CITY OF
West Linn

PLANNING MANAGER DECISION

DATE: October 10, 2023
FILE NO.: DR-23-07
REQUEST: Approval of a Class I Design Review at 1750 Blankenship Rd
PLANNER: Ben Gardner, Assistant Planner

**Summerlinn
 Building TI -
 Roll Up Door**
 1750 BLANKENSHIP RD.,
 SUITE 130 & 140,
 WEST LINN, OR 97068

4. EAST ELEVATION

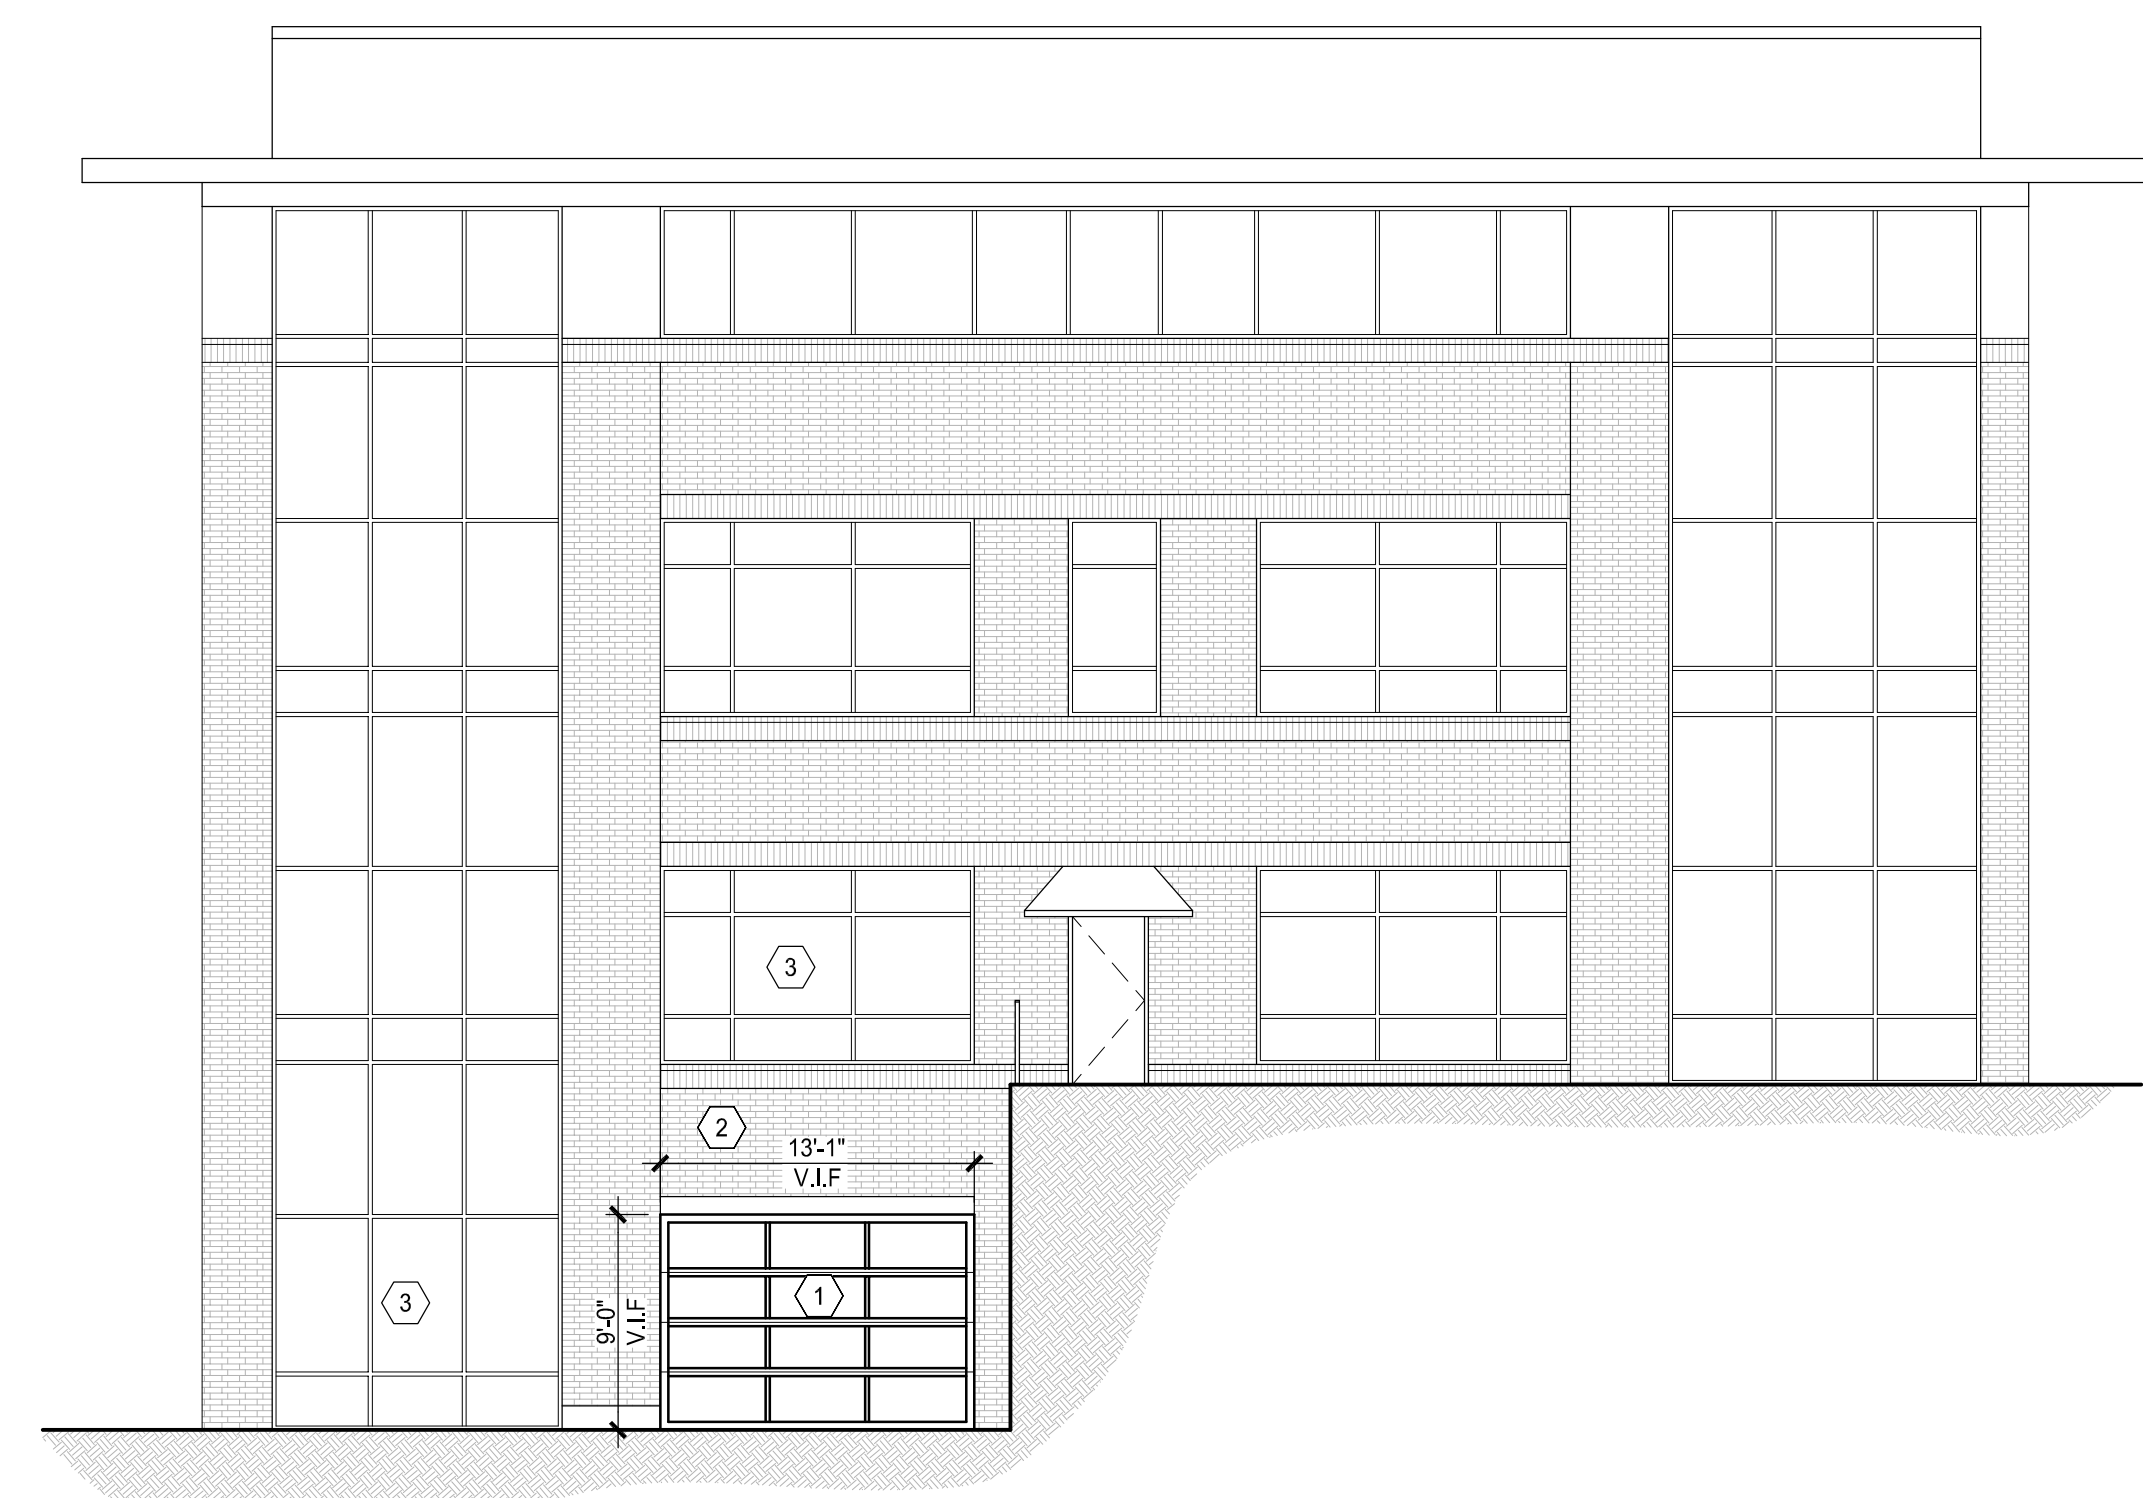
“Seems to me you would be installing a door that is appropriate for an industrial area, not for a residential area. With some creative work, I think they could design an appropriate look for a residential area instead of taking the easy way out. The building was obviously not designed and built to be a warehouse.”

Seems to me you would be installing a door that is appropriate for an industrial area, not for a residential area. With some creative work, I think they could design an appropriate look for a residential area instead of taking the easy way out. The building was obviously not designed and built to be a warehouse.

Staff Response: The subject structure is within the Office Business Center (OBC) zone. The proposed glazing replacement will match the existing glazing style and context of the Summerlinn Center area. Warehouses are not permitted in the OBC zone and a warehouse use is not proposed.
